Intermodal Logistics Centre at Enfield

**Modification Application No. 6
ECI Detailed Design Adjustments
and Subdivision**

Response to Submissions

July 2012

ENFIELD @ ILC
FIGURE 2
DRAFT SUBDIVISION PLAN

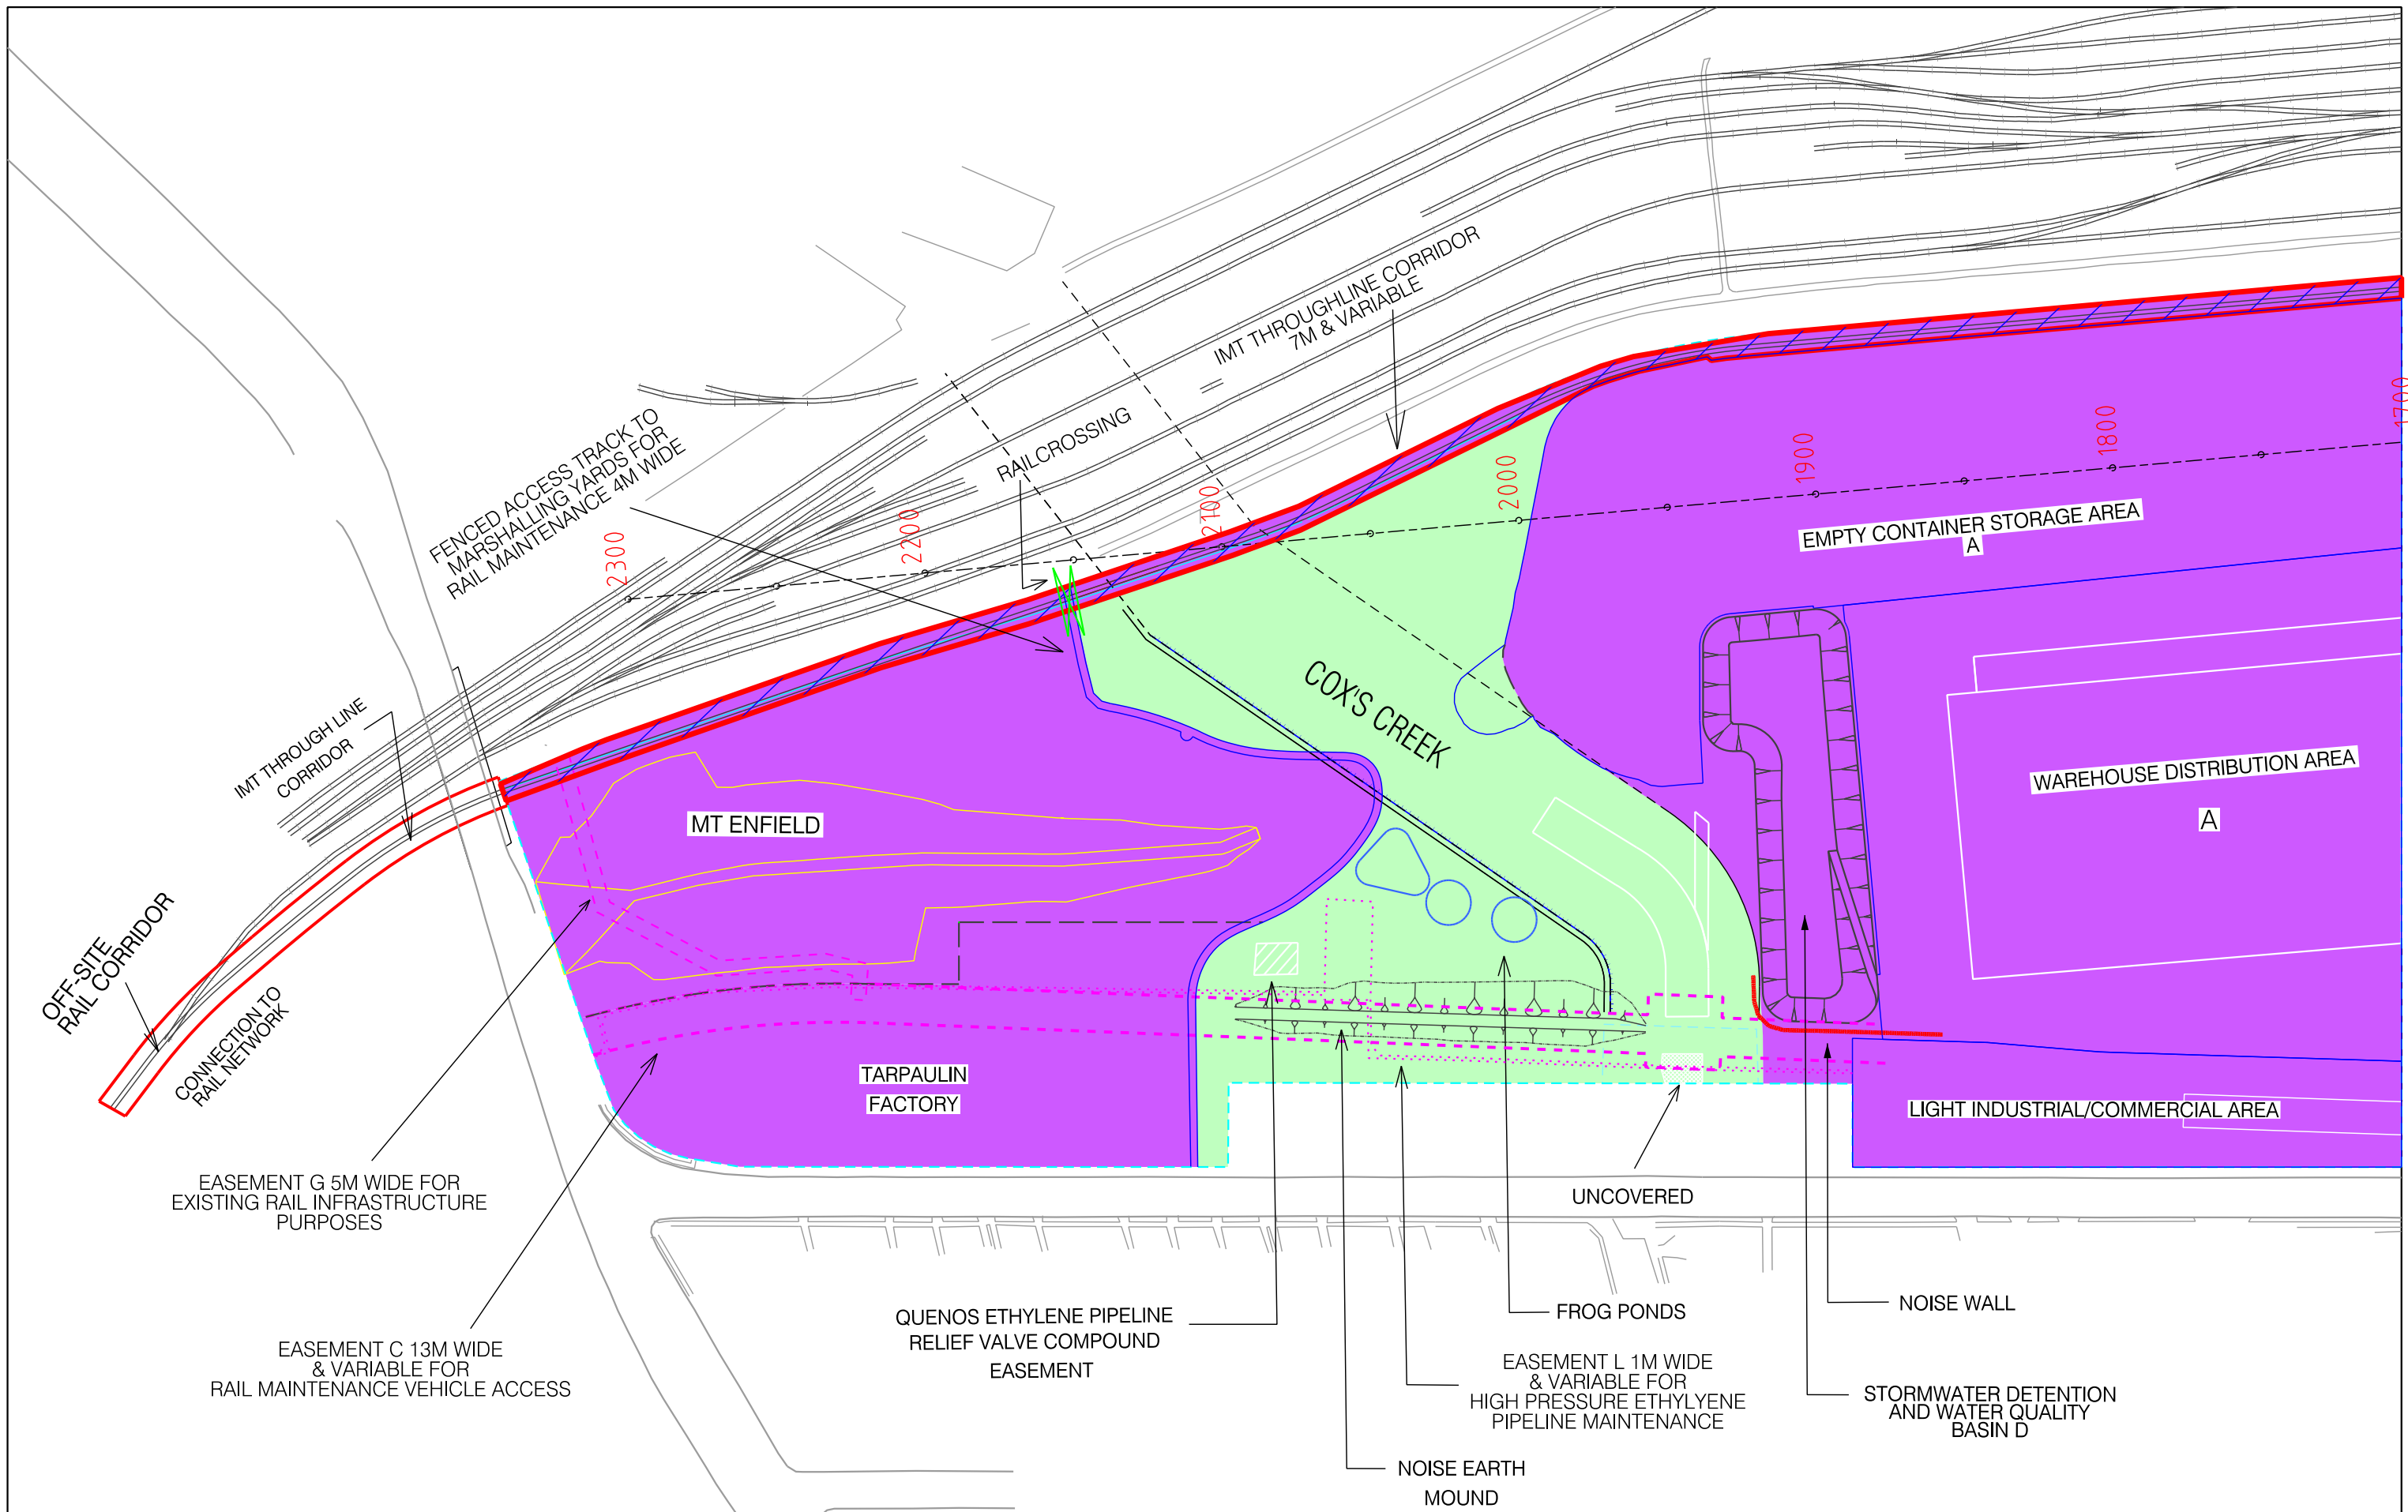
SMC commented that the proposed subdivision pattern conflicts with the intent of the original approval for the southern section of the site becoming a 'Community, Heritage and Ecological Area' and undermines its preservation as it creates potential opportunity for the sale or leasing. SMC also noted that the Strathfield Draft LEP 2011 includes the whole of the originally approved 'Ecological & Community and Heritage Area' as RE1 Public Recreation, with the main section of the ILC site zoned to General Industrial IN1. Currently the entire ILC site is zoned Special Uses B (Railways).

Sydney Ports does not believe that the proposed subdivision conflicts with the original approval for the southern area. Sydney Ports believes that the proposed subdivision pattern in conjunction with the proposed re-zoning as recommended by Sydney Ports' LEP submission would best support and protect the uses for the southern end of the ILC site proposed in the EA.

The subdivision pattern has been designed to allow the uses proposed in the EA. The proposed subdivision does not diminish the amount of land dedicated in the original approval for community, ecological and heritage purposes. Furthermore, the creation of Lot 19 enhances the potential for heritage related opportunities by defining the extent of the Tarpaulin Factory curtilage. This curtilage includes a rail access corridor previously known as the DELEC south sidings rail corridor adjacent to the shed (approximately 13 m wide) and the Qenos pipeline maintenance corridor (approximately 1 m wide).

Sydney Ports believes that the proposed subdivision pattern in conjunction with the proposed re-zoning as recommended by Sydney Ports' LEP submission would best support and protect the uses for the southern end of the ILC site proposed in the EA. Using this approach Lots 19 and 25 would be zoned IN1 industrial while Lot 20 would be zoned RE 2 – Private Recreation.
